1 Products affected

2 Type of change

Product Change Notification				PCN 6762 (screw-on)			
owner	creation date	release date	released by	change order no	rev	page	D10 012 010
huberth	19.03.2020	26.03.2020	muehlema	2019628	Α	1 of 2	D10-043-840

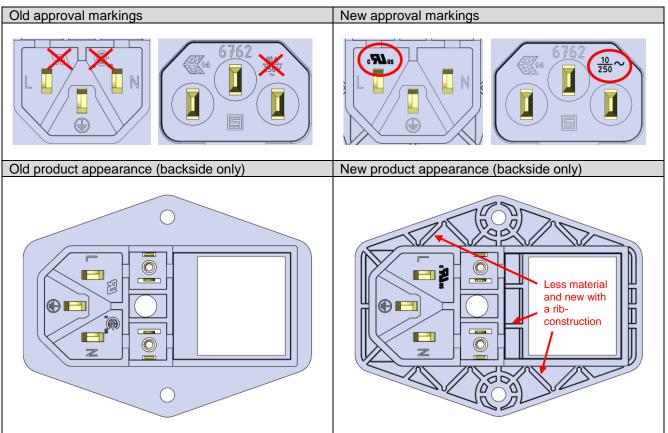
- 1. Change of approval markings from UR and CSA to the combined cURus on the product socket according to standard update of UL/CSA 60320-1
- 2. Backside of flange with ribs and less material

Form Yes 1. Socket new with cURus approval marking

Form Yes 2. Less material and new a rib construction on the backside of flange

- 1. The change is due to a standard update to UL/CSA 60320-1
- 2. To improve the moulding process and to avoid flow lines
